尊敬的高原 GOYEN 产品客户：

GOYEN Controls Co. Pty. Ltd. has invested in new sets of tooling for the production of RCAC25DD4 Series of valve bodies. We've also added a rib at the body in order to enhance the physical strength of the body, as shown on the following photos.

Goyen Controls Shanghai Rep. Office

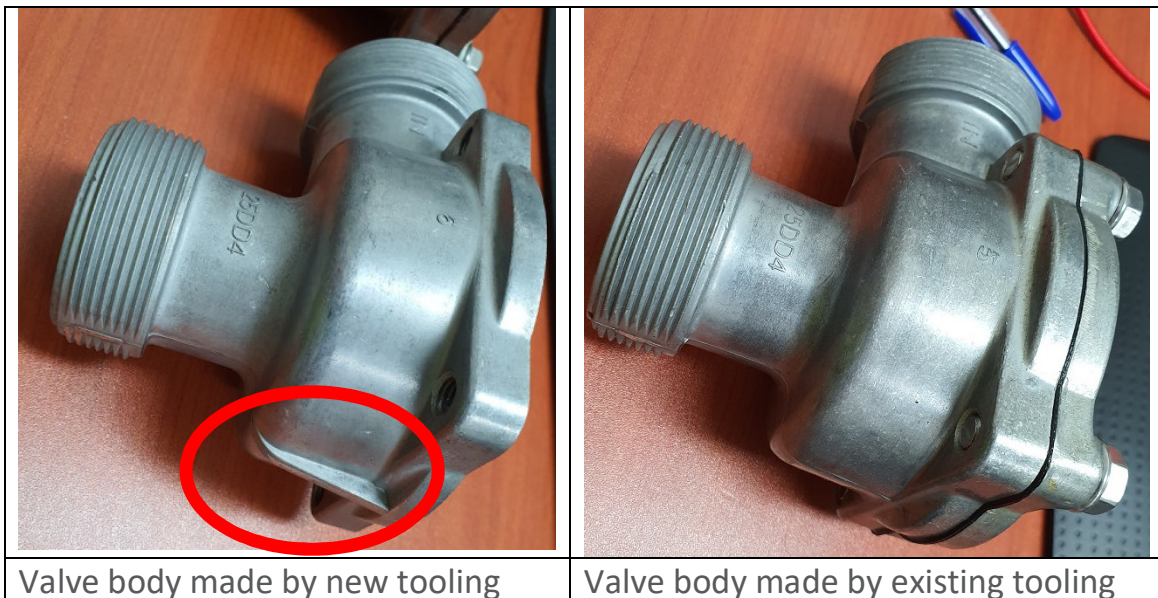
澳大利亚高原公司已为产品型号 RCAC25DD4 系列阀体生产设备增添新模具，同时为阀体增加一条加固肋条，可加强阀体刚性，如下图。

在今后几个月的交货期，客户将收到以下两种阀体的任何一种款式。这些阀门均为澳大利亚原装进口产品，直到高原公司停止使用现有模具，届时全部阀体都带有加固肋条。

Effective immediately Goyen will dispatch either type of RCAC25DD4 valve with the following two body configurations until the current molds to be scrapped. By that time all valves shall bear a rib at the body.
